WILLIAMSON COUNTY, TEXAS

CHANGE ORDER NUMBER: 1

Project:	<u>Ronald Reagan at Silver Spur & Sun City</u>
Roadway:	<u>Safety Improvements</u>
Project Number:	<u>T1873</u>

Change Order No. 1 Reason for Change

REFERENCE: Plan Sheet 39 and attachments, concerning center median, exit side of Silver Spur

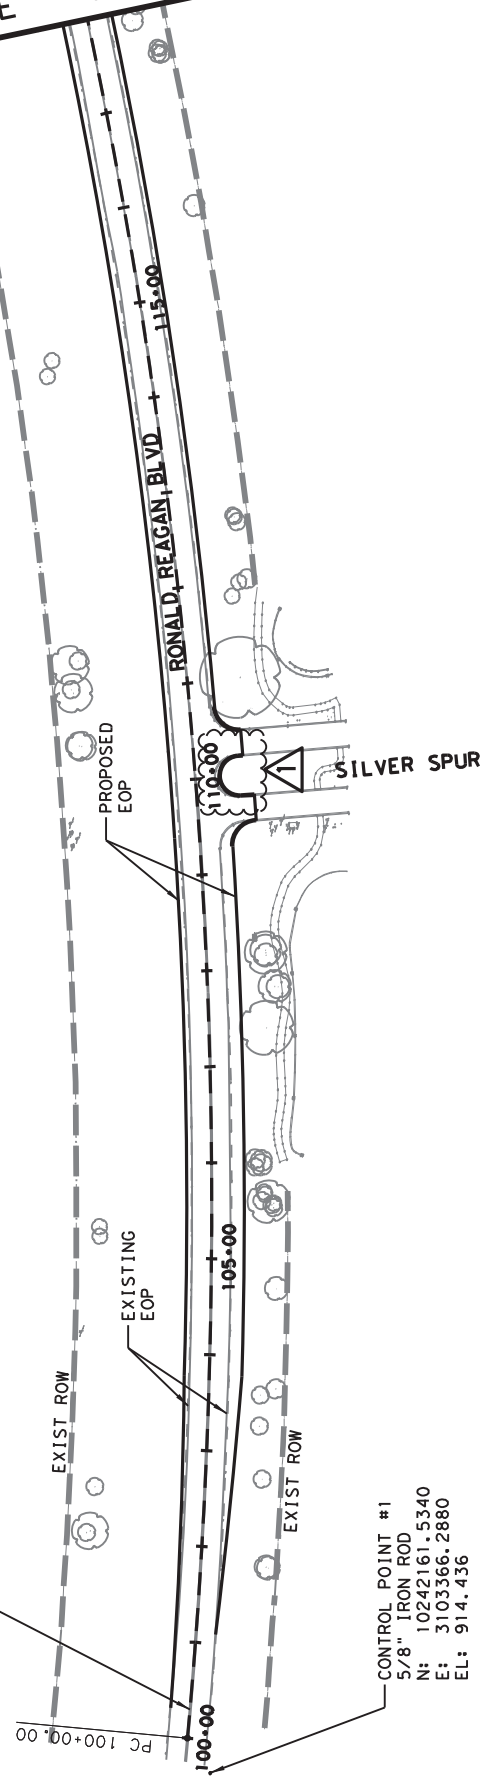
PROBLEM: Maintain profile of exit portion of Silver Spur, minimize construction

Refer to attached survey information of existing roadway. Plans show center median offset to match the edge of pavement of right turn lane. This creates a lot of work to modify profile of exit side of Silver Spur. Also need to maintain platform where traffic stops to enter Reagan Blvd. Let me know if you have any questions or need to discuss situation.

We would like to propose to move the center median radius forward to match the offset of the typical roadway widening north of Silver Spur. By moving the radius point, we would minimize the grade change of the exist side portion of Silver Spur. Our goal is to minimize the work so that it can be accomplished with daily short term single lane closures. Alternate route for full closures are long and inconvenient for traffic.

Attached are the updated plan sheets, including an updated driveway detail sheet.
